Addendum No. 001

Subject: George W. Childs School – Classroom Modifications
SDP Contract Nos. B-071C, B-074C of 2017/18

This Addendum, dated May 9, 2018, shall modify and become part of the Contract Documents for the work of this project. Any items not mentioned herein, or affected by, shall be performed strictly in accordance with the original documents.

DRAWING NO.
A105

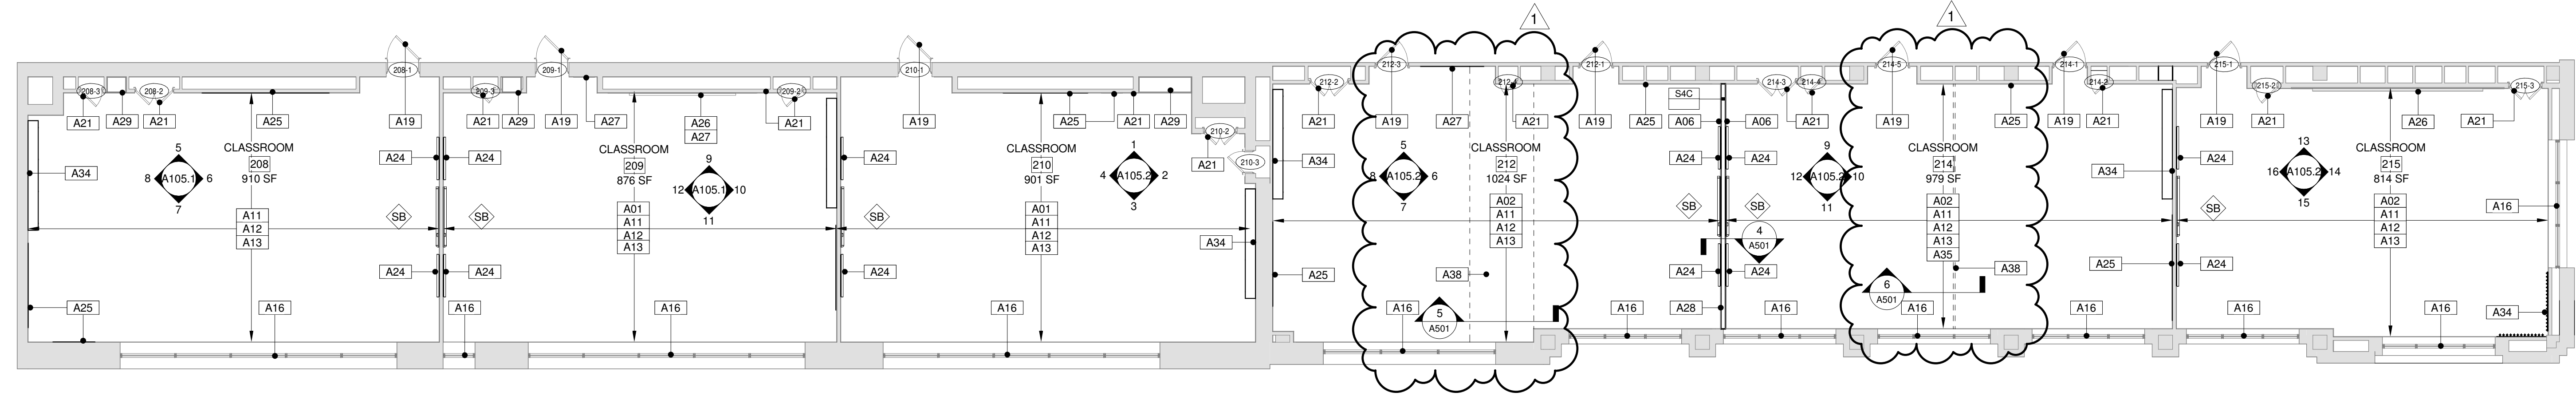
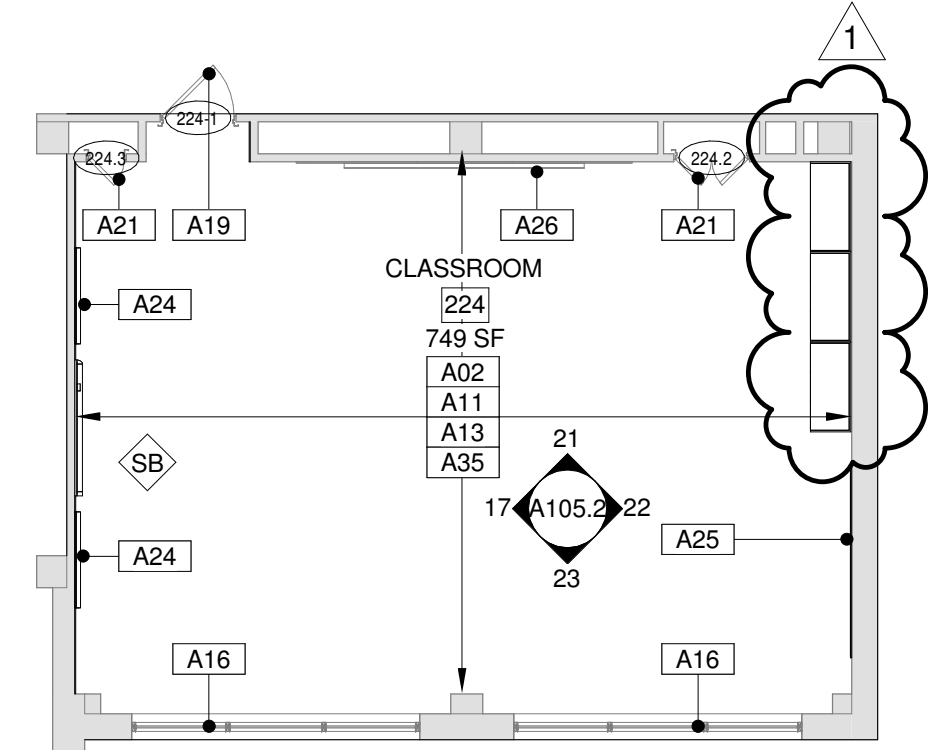
- a. Partial Second Floor Plan Area E, 3/A105: See attached revised drawing A105 for new detail locations.
- b. Partial Second Floor Plan Area E, 3/A105: The renovation note tag A06 on both sides of the new wall between Classroom 212 and Classroom 214 should be changed to renovation note tag A39.
- c. See attached revised drawing A105 for revised Composite Second Floor Plan, 2/A105, renovation tag A34 changed to A30.

4 NEW PARTITION DETAIL

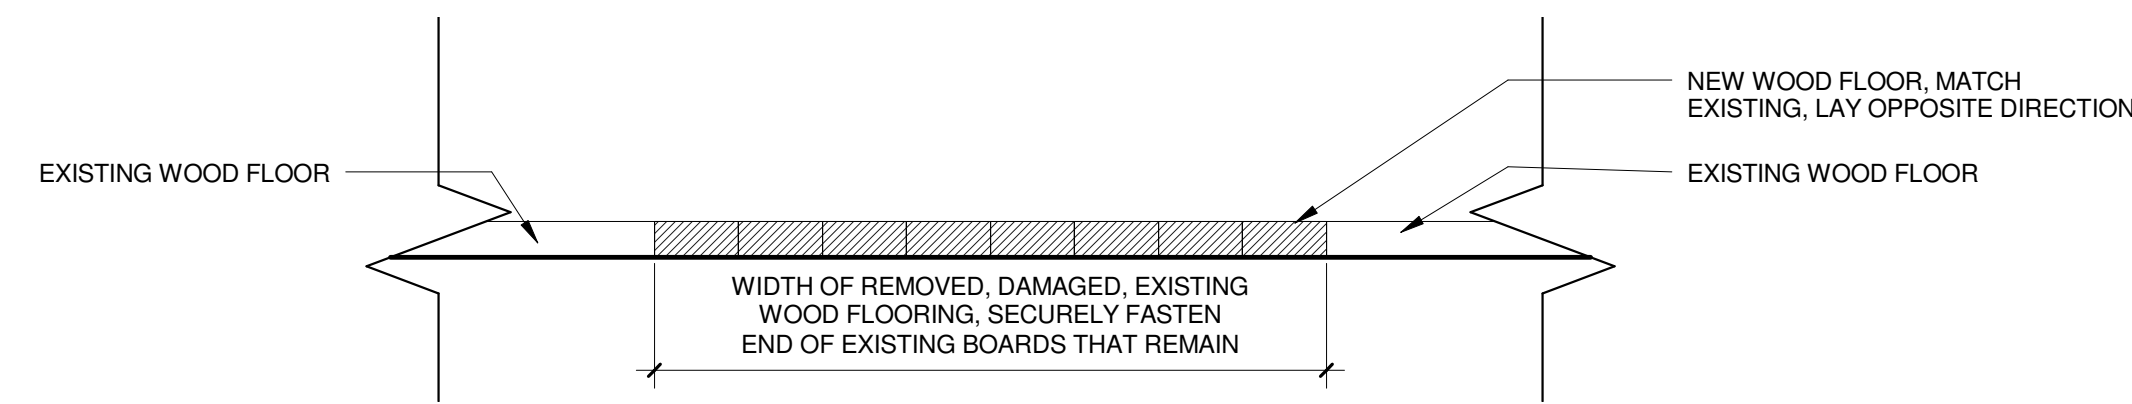
- a. New Partition Detail 4/A501: See attached revised drawing A501 for revised detail.
- b. See attached revised drawing A501 for new wood floor repair details.

DRAWING NO.
ED101

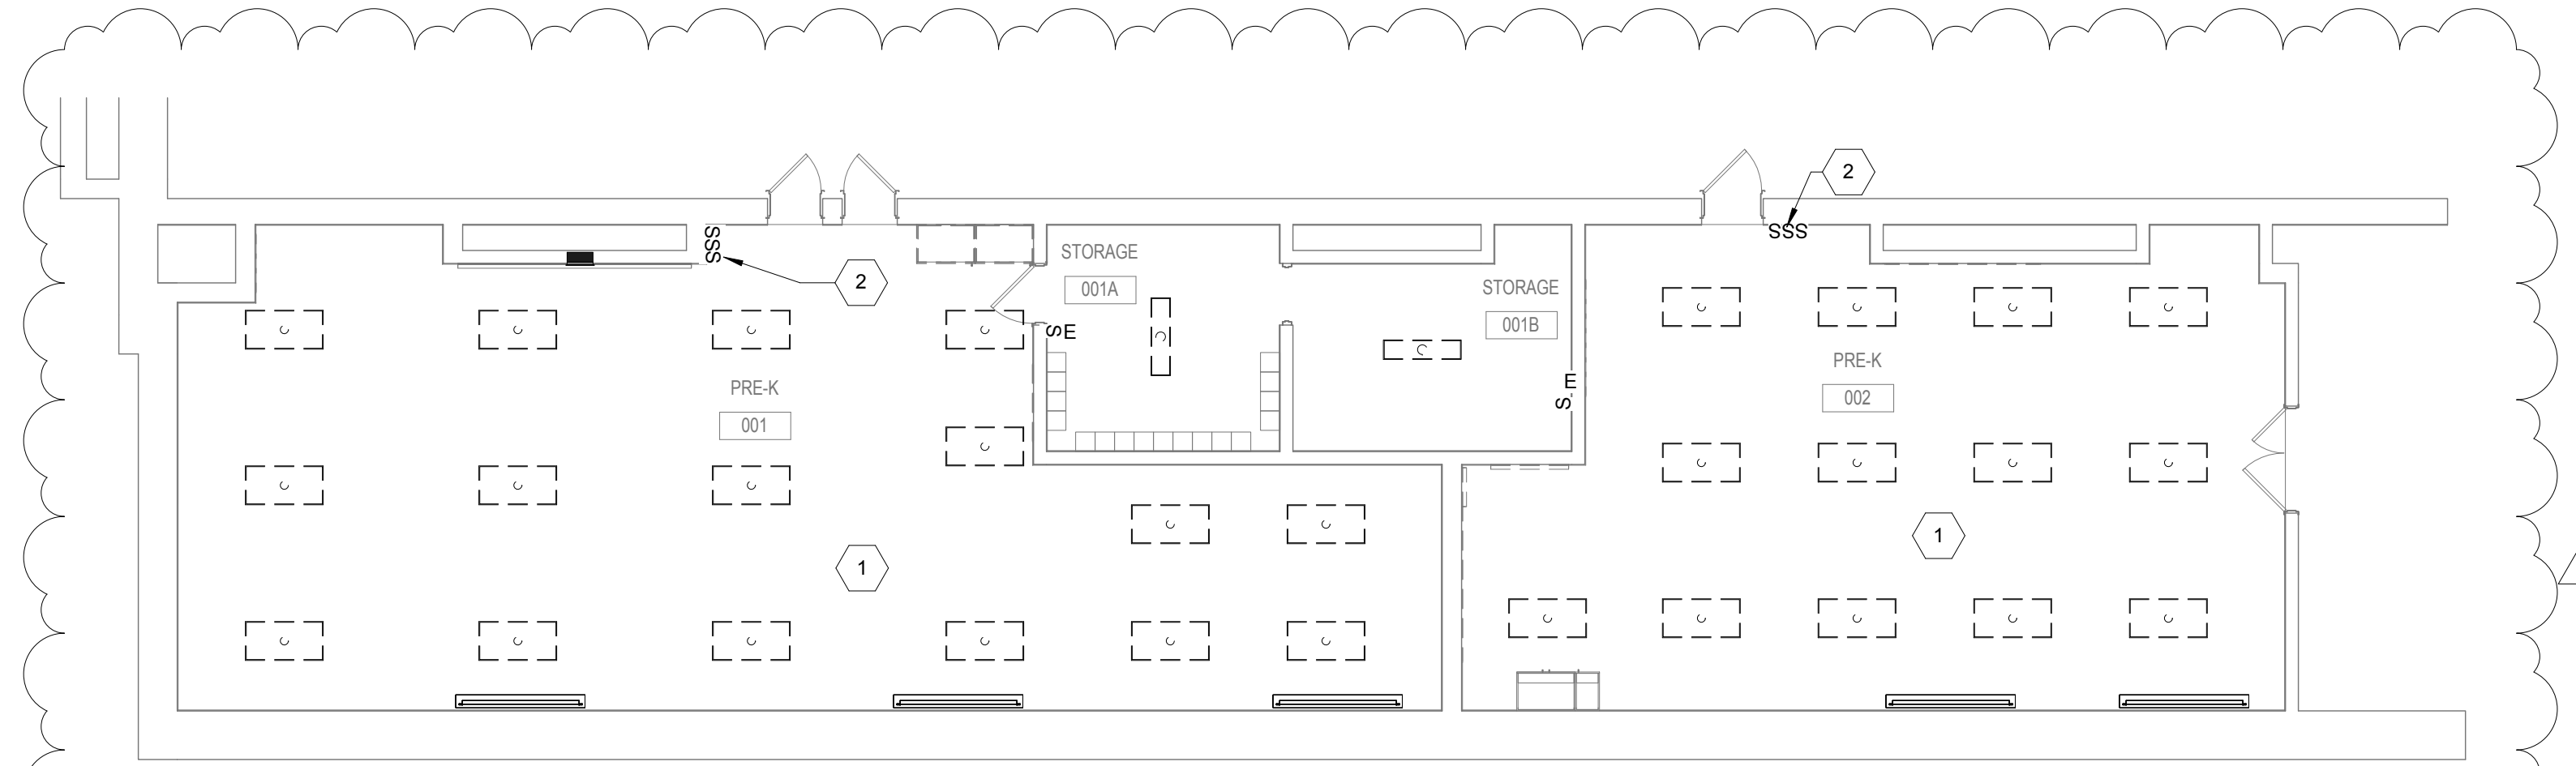
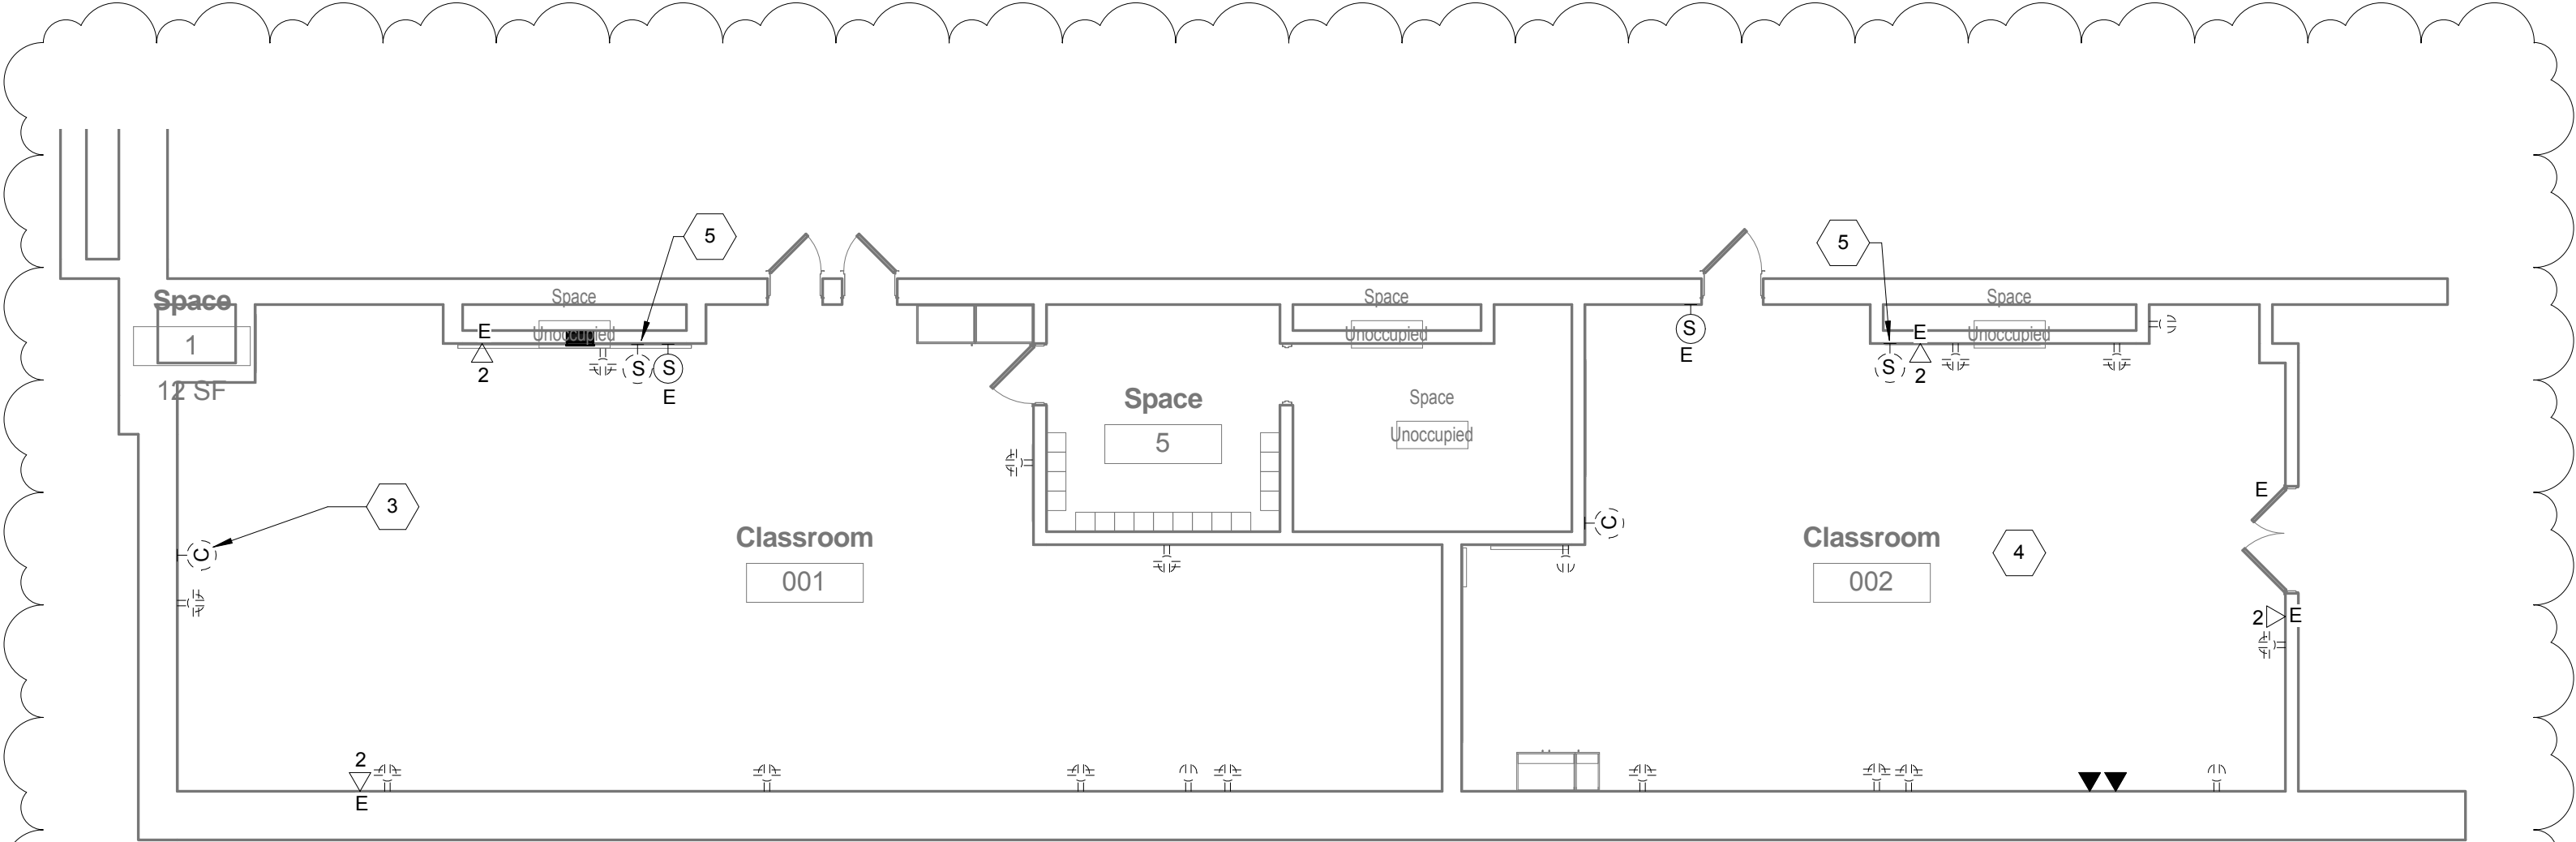
- a. Revise existing lighting and power layout in rooms 001 and 002. Added key plan, graphic scale and north arrow.

DRAWING NO.
ED111

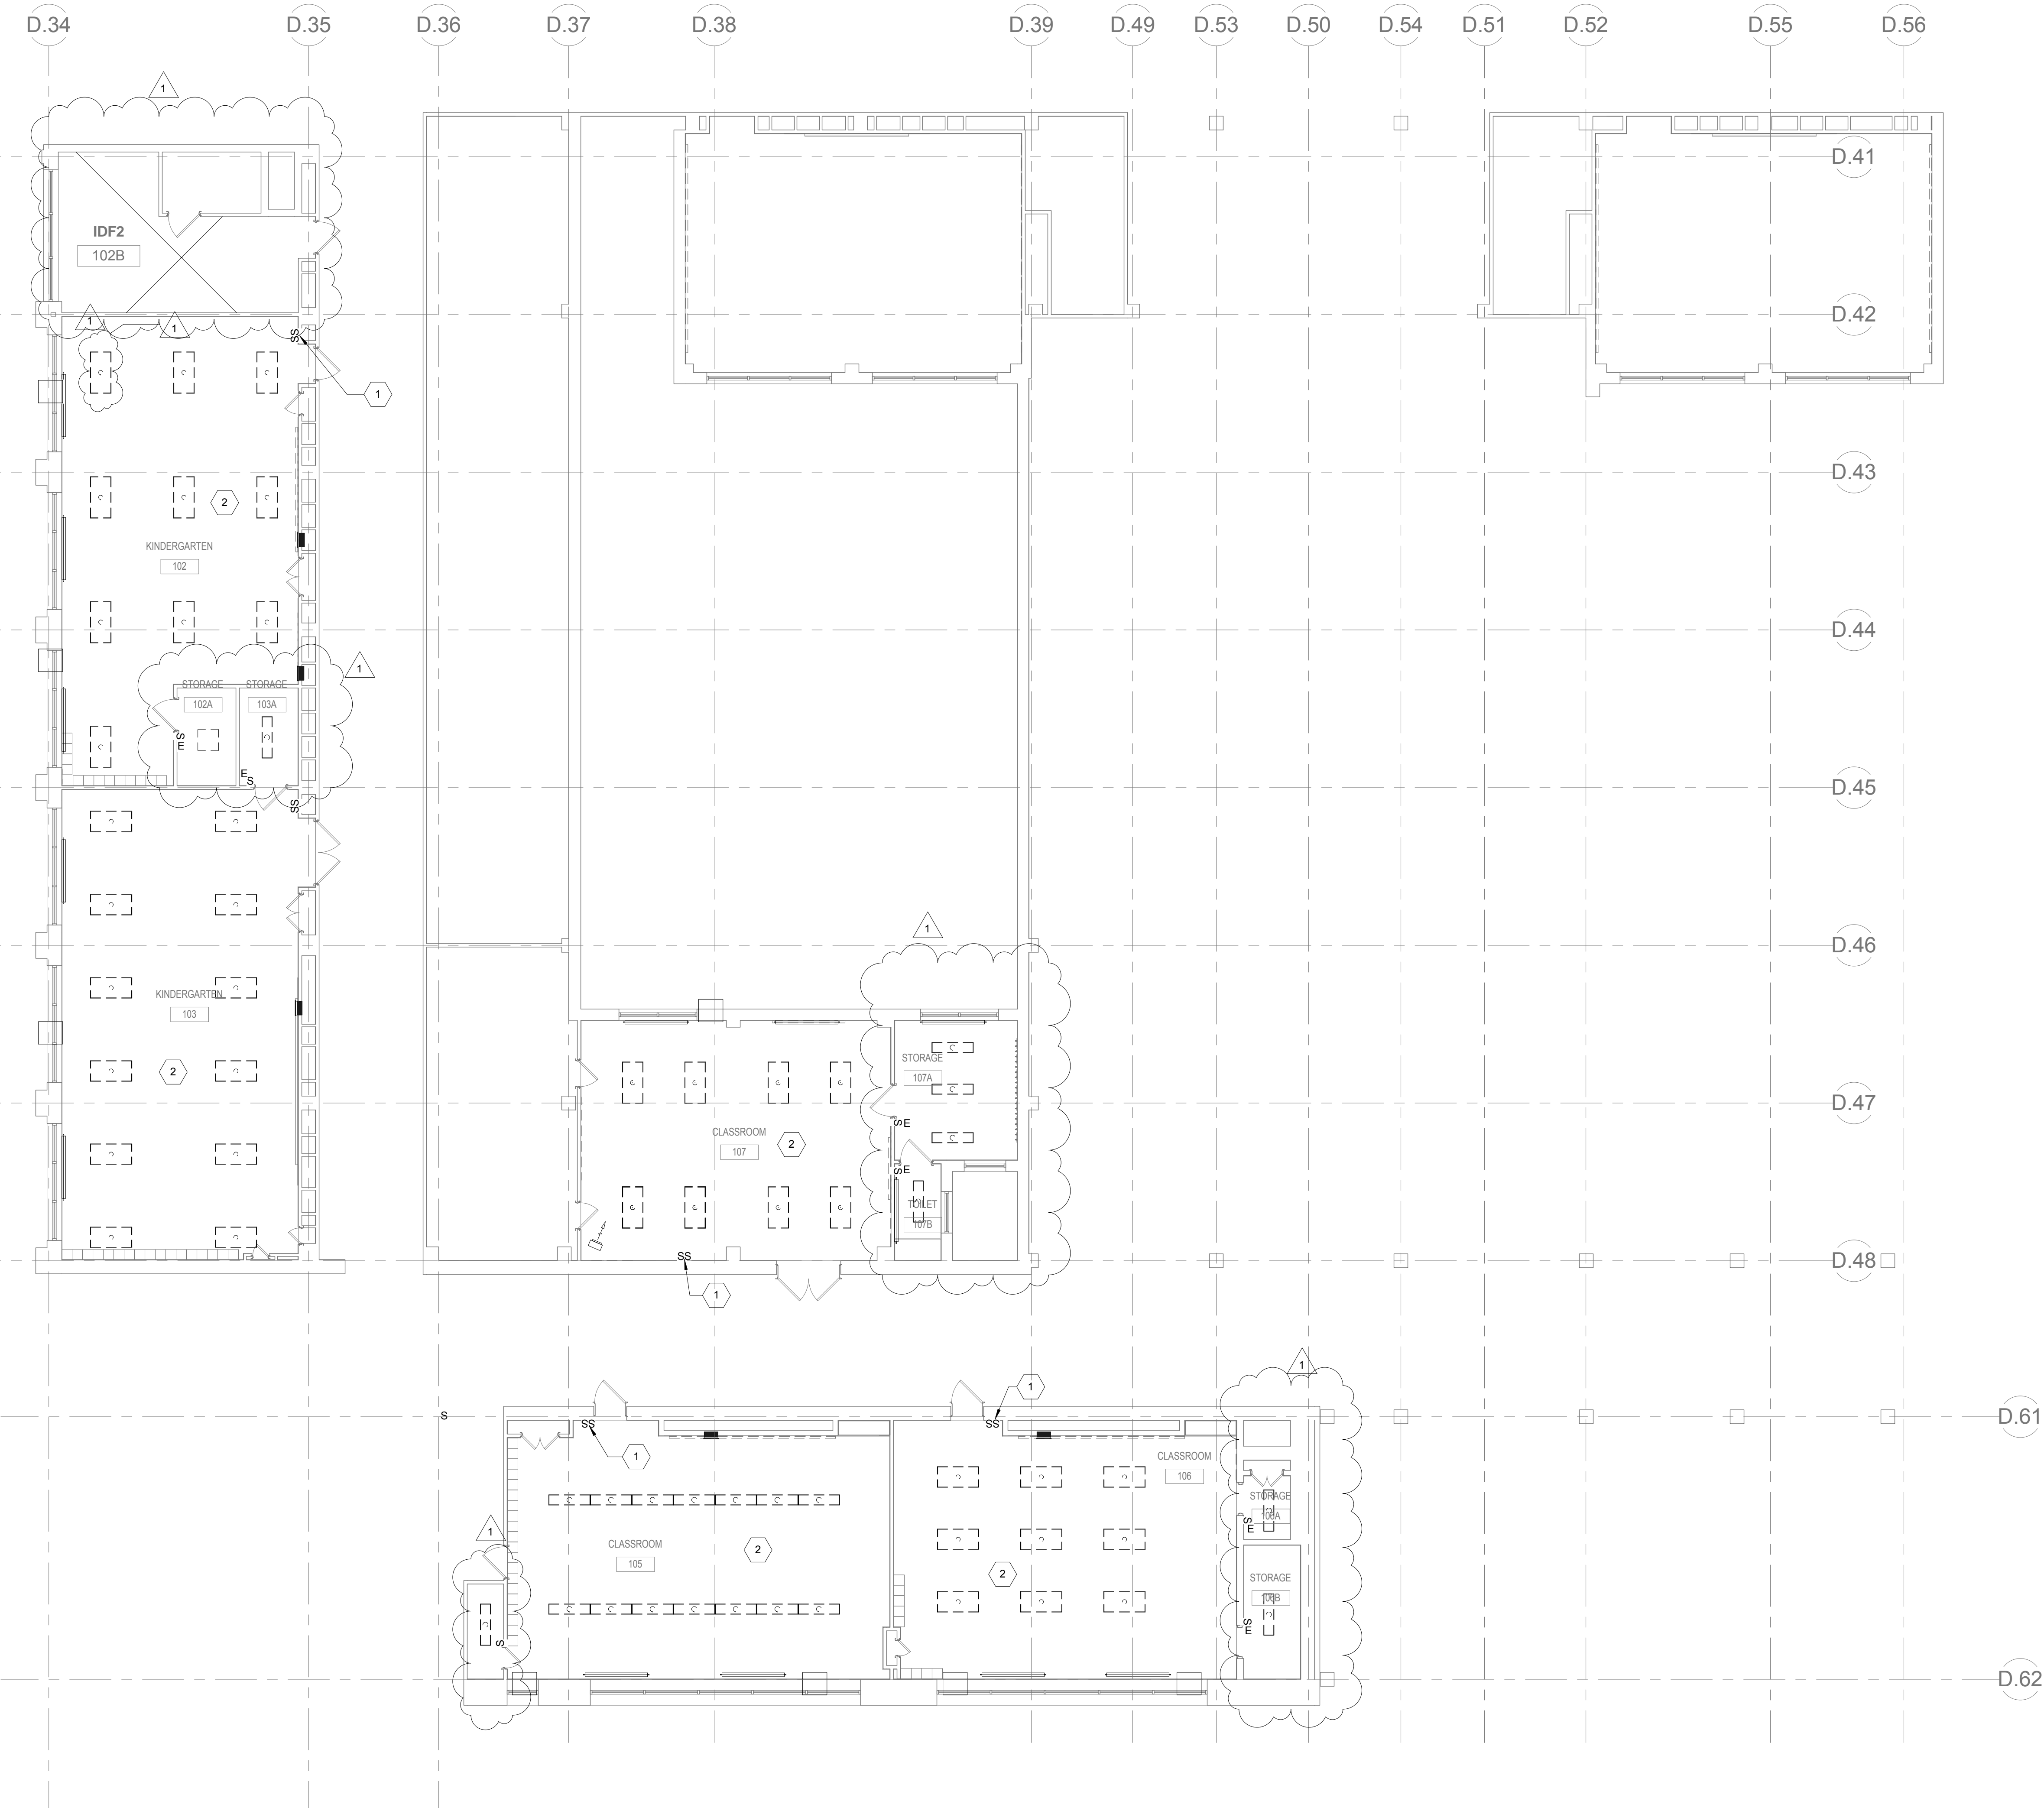
- a. Added existing lighting in toilets and storage rooms.
- b. Added IDF2 ROOM 102B.
- c. Added key plan, graphic scale and north arrow
